**Re:** **Caivano Residence**  
**Minor Subdivision and Bulk Variances**  
243 & 257 Hollow Road  
Block 12001, Lots 14 & 16  
R-5 Residential Zone

**Date:** April 19, 2021

Re: Caivano  
257 & 243 Hollow Road  
Montgomery Township  
Somerset County, New Jersey  
Block 12001, Lots 14 and 16  
**Minor Subdivision, Lot Line Adjustment**  
**Bulk Variance**  
**Review #2**  
Application #PB-10-20

To: Montgomery Township Planning Board  
From: Lauren A. Wasilauski, Open Space Coordinator  
Date: April 13, 2021  
Re: PB-10-20: Wayne & Betsy Caivano  
Block 12001 Lots 14 & 16  
257 Hollow Road, Skillman  
Minor subdivision with variance

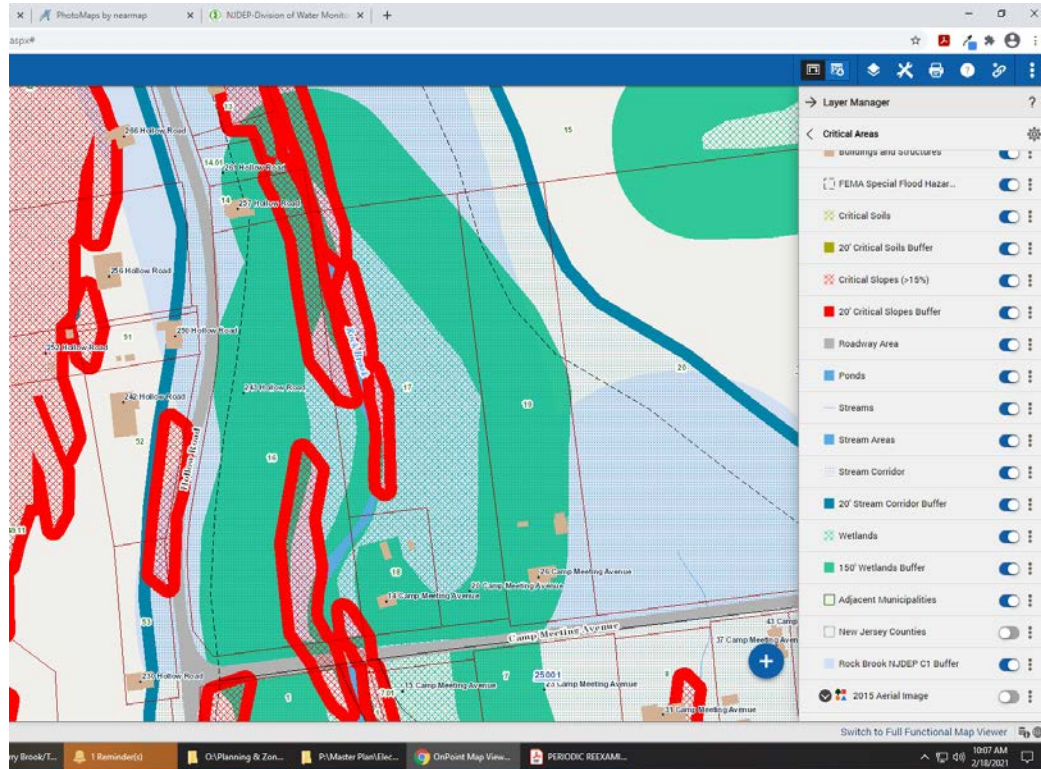
1. Township Code Section 16-5.14C requires sidewalks along all public roadways, except in the MR zoning district.
2. The applicant's plans do not propose any sidewalk.
3. This office defers to the Township Engineer on whether a right of way dedication is needed on Camp Meeting Avenue to accommodate a future sidewalk in this location. A sidewalk along

Camp Meeting Avenue is indicated on the Pedestrian-Bikeway Corridor Plan (attached). The Township is actively engaged in constructing pathways in the vicinity.

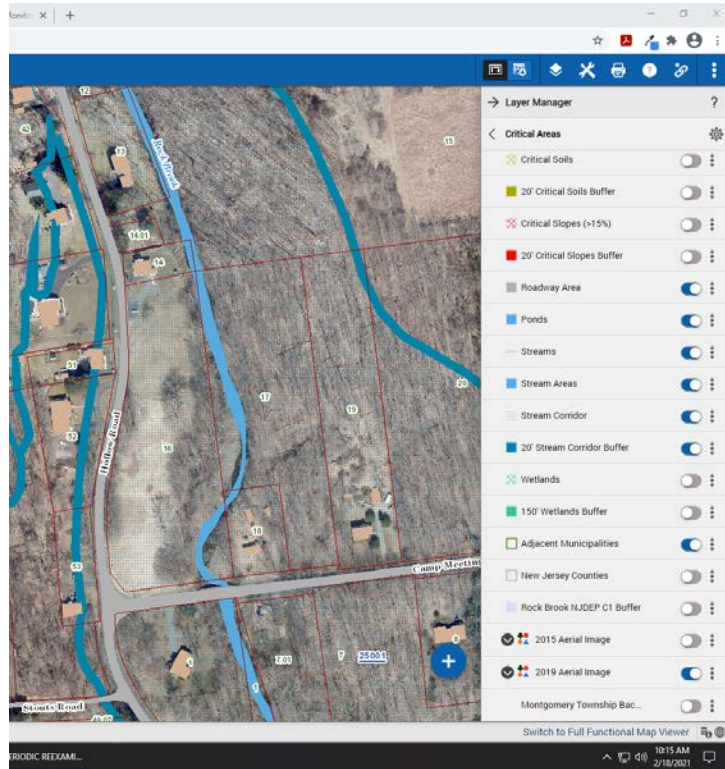
- b. The applicant is requesting a waiver of the tree planting requirement.
  - c. According to NJDEP infrared photography and Township mapping, the entirety of the site is impacted by one or more critical areas, including Township stream corridor, assumed wetlands and associated buffer areas, steep slopes and associated buffer. The property lies entirely within the Rock Brook Category One stream buffer (see map on following page).

- i. Rock Brook – from its headwaters in Hillsborough to Camp Meeting Avenue – was reclassified last year by NJDEP as a Category One stream. A Category One stream is the highest designation in New Jersey for streams that are exceptionally important to ecology, water quality, and water supply.

- d. This office does not support the granting of the waiver for tree planting. The required number of trees should be planted to enhance these areas, much of which appears to be mowed grass (see aerial image on following page).
  - i. An exception to this recommendation is explained in section C of this memo regarding the use as a former landfill.
  - ii. If NJDEP regulations regarding former landfill sites do not permit planting of trees, the applicant may instead contribute funds toward the Township Tree Bank per Township Code Section 16-5.6.d.3.b.

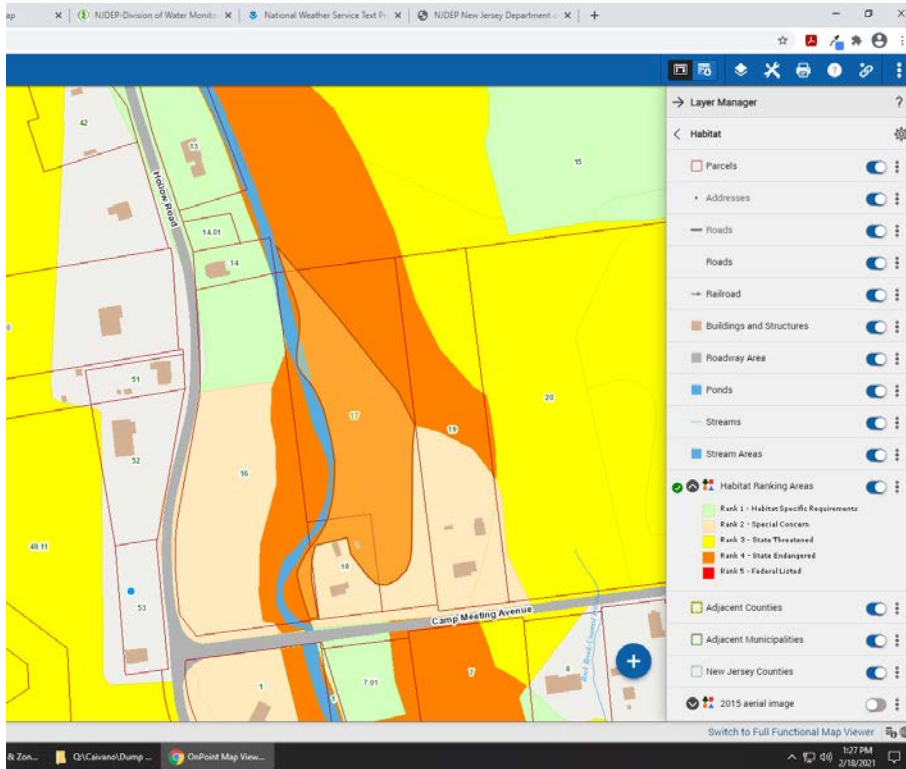
1. According to the NJDEP and Township's mapping, the entirety of the property is impacted by one or more critical areas. Township Code Section 16-5.6e requires a conservation deed restriction or conservation easement on all critical areas.
2. A portion of Lot 16 is indicated as habitat for threatened & endangered species, specifically the State endangered Bald Eagle (see map on following page). Code Sections 16-5.2(e) & (g) and 16-6.4(e) require threatened and endangered species habitat to be protected by a conservation easement or deed restriction.
